Florida Department of Transportation

RE: Pre-application Review for **Category C Driveway**, Pre-application Meeting Date: **August 17, 2023**

Broward County - Pompano Beach; SR 5; Sec. # 86020000; MP: 11.9; Access Class - 5;

Project Name & Address: **El Car Wash Pompano Beach – 3685 N Federal Highway, Pompano Beach, Florida**

SP-1

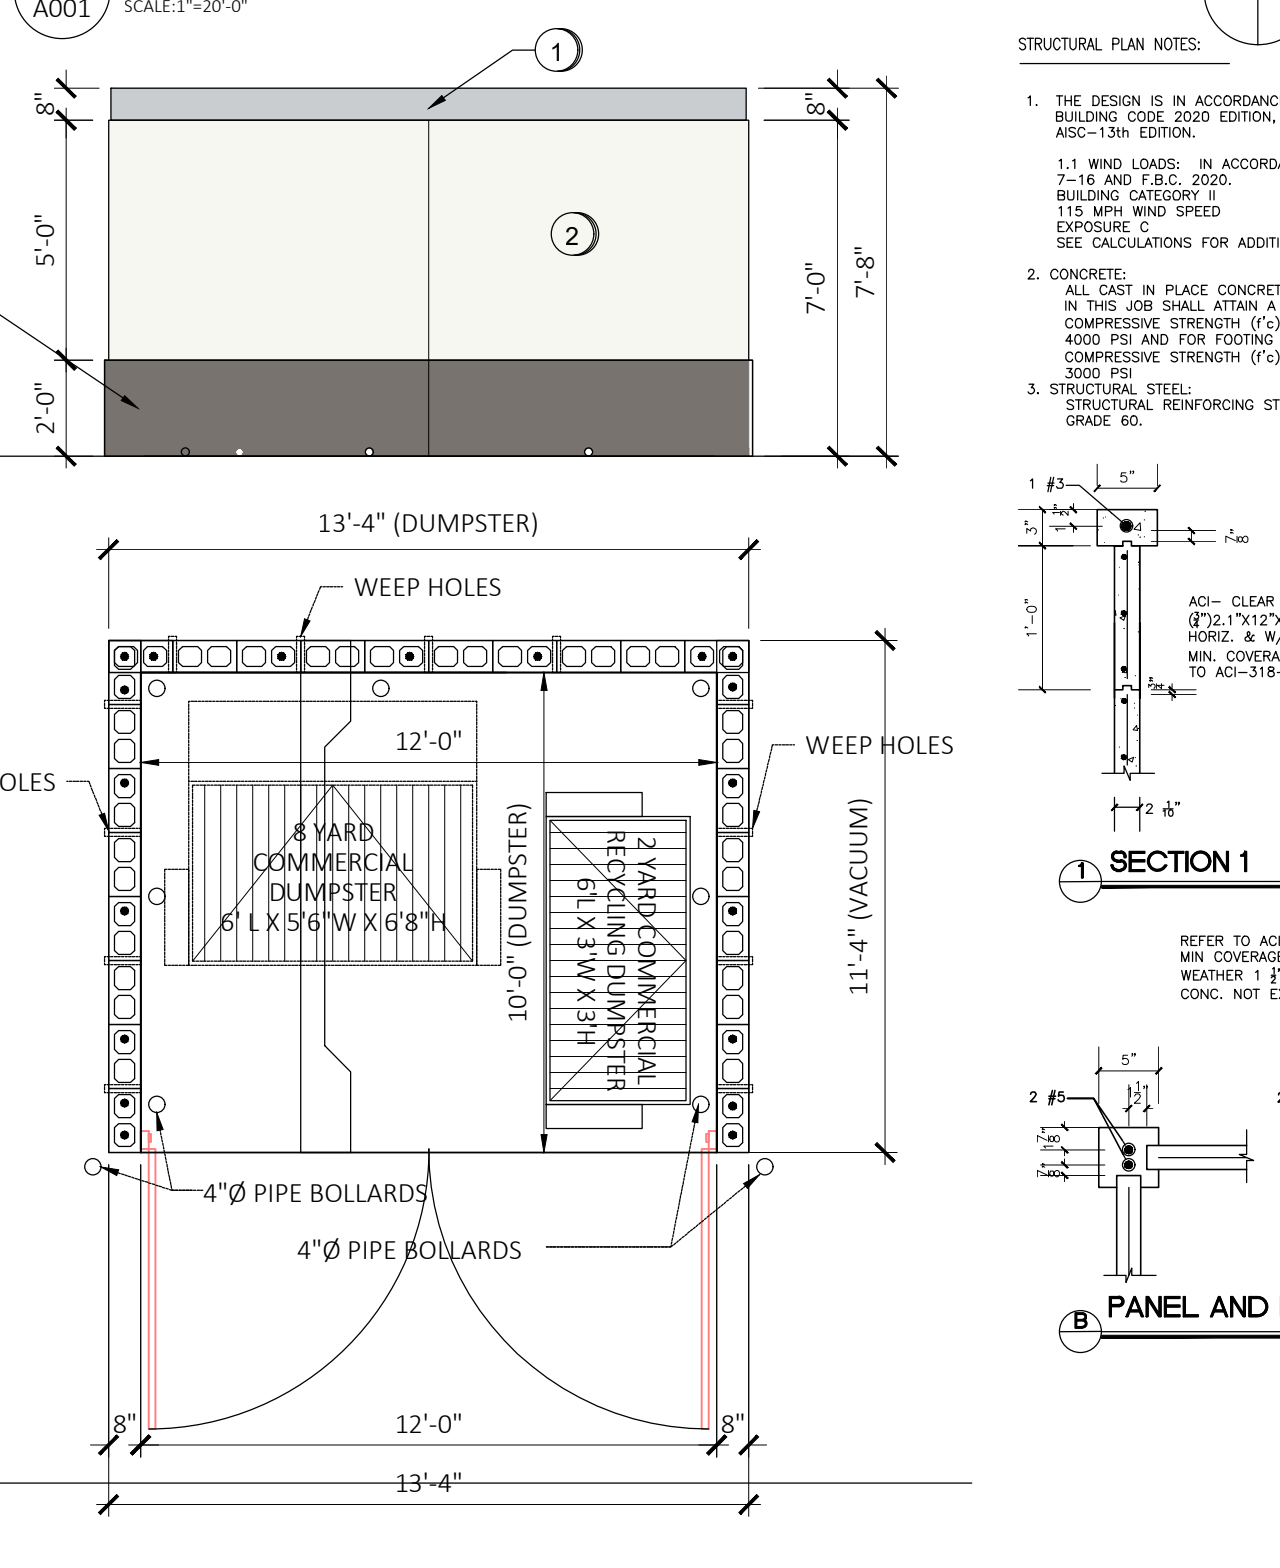
This decision is based on your presentation of the facts, site plan and survey - please see the conditions and comments below. You may choose to review this concept further with the District Access Management Review Committee (AMRC).

- **A minimum driveway length of 25 feet, as measured from the ultimate right-of-way line to the first conflict point shall be provided.**
- **If a gate is proposed, a minimum driveway length of 100 feet to the call box and/or gate house, and a turnaround area before the gate are required.**

- All driveways not approved in this letter must be fully removed and the area restored.
- A Drainage Permit is required for any stormwater impacts within FDOT right-of-way (i.e. increased runoff or reduction of existing storage).
- The applicant shall donate property to the Department if right-of-way dedication is required to implement the improvements.
- Dimensions between driveways are measured from the near edge of pavement to near edge of pavement and for median openings are measured from centerline to centerline unless otherwise indicated.
